CHINMAYA MISSION

NEW FACILITY

PRELIMINARY DEVELOPMENT PLAN

A1.1 SITE PLAN

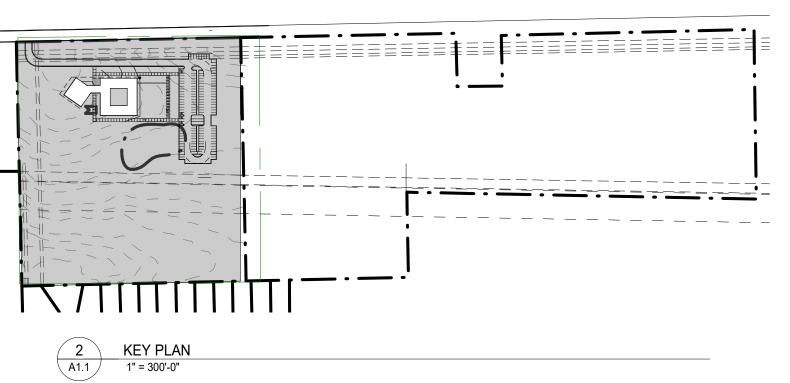
RESPONSE TO 1/22/20 STAFF COMMENTS					
View Type	#	RESPONSE				
PLANNING	7	SIDEWALK CONNECTION FROM THE INTERIOR OF THE SITE TO PFLUMM ROAD, COMPLYING WITH UDO, SECTION 18.15.125.B.				
PLANNING	8	DRAINAGE FEATURE PER UDO 18.15.125.C .1				
PLANNING	10	40' MIN, LANDSCAPE BUFFER WITHOUT FENCE PER UDO 18.15.125.D.2.A				
PLANNING	12	FENCE PER UDO 18.30.130.I.8				
PLANNING	15	TYPE 1 BUFFER ALONG THE NORTHERN PROPERTY LINE AND SOUTHERN PROPERTY LINE, TYPE 5A BUFFER ALONG THE WESTERN PROPERTY LINE PURSUANT TO UDO,				
		SECTION 18.30.130.J, TABLE 18.30.130-1.				
PLANNING	16	NONRESIDENTIAL LANDSCAPING PURSUANT TO UDO, SECTION 18.30.130.L.2 PROVIDED				
PLANNING	18	FOUNDATION LANDSCAPE TO BE PROVIDED PER UDO, SECTION 18.30.130.O.				
PLANNING	19N	LOCATION OF PROPOSED EXTERIOR GROUND MOUNTED MECHANICAL OR UTILITY EQUIPMENT TBD				
PLANNING	21	SEE DRAWING				
PLANNING	22	SEE DRAWING				
PLANNING	23	DUMPSTER/TRASH ENCLOSURE WITH 7' TALL MASONRY WALL WITH STUCCO FINISH ON THREE SIDES, METAL GATE TO MATCH

PLANNING	25	5' MIN SIDEWALK UDO 18.30.180.A.1				
PLANNING	26	PROPOSED BICYCLE PARKING FACILITIES				
PLANNING	37	GUTTERS AND DOWNSPOTS TO COMPLY WITH THE REQUIREMENTS OF UDO, SECTION 18.15.020.E.9.
